FINAL ENVIRONMENTAL IMPACT REPORT

CAMP SWEENEY REPLACEMENT PROJECT

SCH # 2015102054

April 2016

Figure 6.3 Results of Seismic Investigations to Determine Zones Safe for Buildings

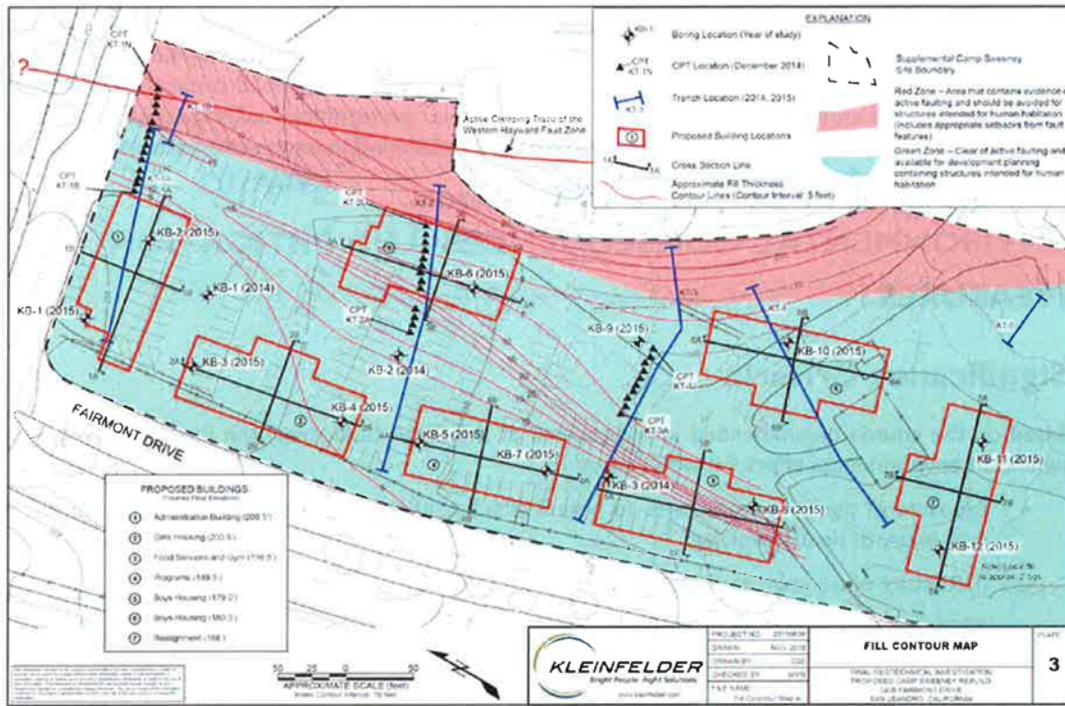
Subsequently, Kleinfelder's *Phase 3 Fault Investigation* (February 2015) was performed to provide additional exploration in the Orange Zone for signs indicative of active faulting. After the Phase 3 investigation and assessment was complete, the Orange Zone was determined to be clear of active faulting and became part of the Green habitable zone. A graphic depicting the final delineation of the red and green zones and the resulting site plan showing building footprints and other data is presented in **Figure 6.3**.

Handwritten note: GEOTECHNICAL AND FAULT

9. Chapter 6, Page 6-7, change the wording of Figure 6.3:

Figure 6.3 Results of ~~Seismic-Geotechnical~~ and Fault Investigations to Determine Zones Safe for Buildings
